SERVICE BULLETIN

No. 300-1-98

- Subject:** Front seat, installation of a lap belt guide
- Aircraft affected:** EA-300/200 SN 01 through 23,
24 and on are factory equipped with the lap belt guide.
- Purpose:** A rudder pedal lock due to interference with the front seat belt harness has been reported.
- Approval:** The technical content of this Service Bulletin has been approved by LBA.
- This service bulletin is approved by the Manager, Small Airplane Directorate, ACE-100, Federal Aviation Administration of the United States, by letter dated May 20, 1998, as an alternate means of compliance for United States Airworthiness Directive 97-22-03.

Figure 1
Left pedal shown

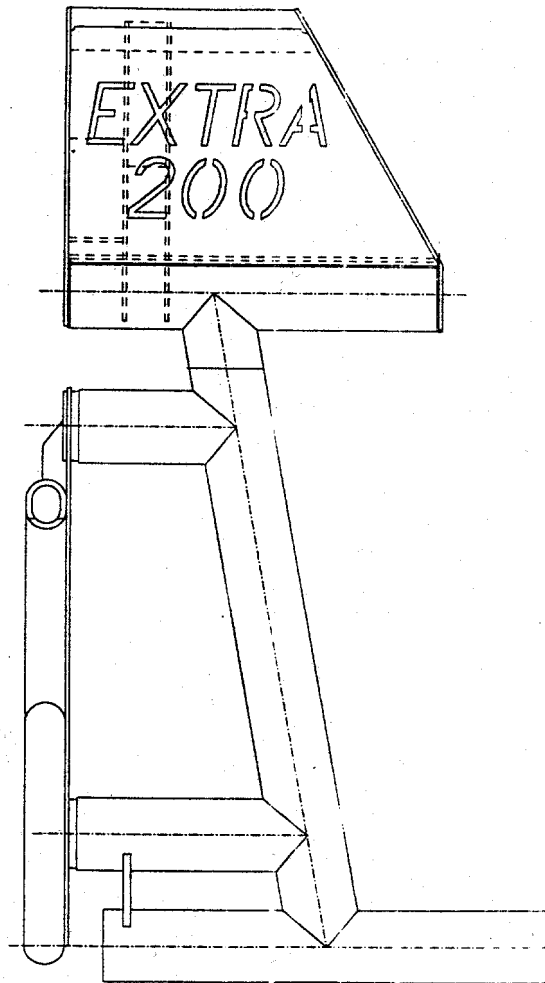
- Remove safety covers installed according Service Bulletin 300-1-97.
- Substitute the old brake pedals by the new ones (see figure 1).
 - > Disconnect the pedal from the brake cylinder stem.
 - > Remove the stopper screw.
 - > Unscrew the pedal by loosening the screws at the left and right end of the axle.
 - > Install the new pedals.
 - > Re-connect the arm to the stem and put the stopper in place
- Install new lap belt according chapter 25-10-03 of the Service Manual.
- Drill holes into the flange of the seat pan using the guides as templates (see figure 2)
- Install lap belt guides (see figures 2 and 3).
- Check pedals of free movement in any adjustable position.
- Make appropriate entry of compliance with this service bulletin in the aircraft log.
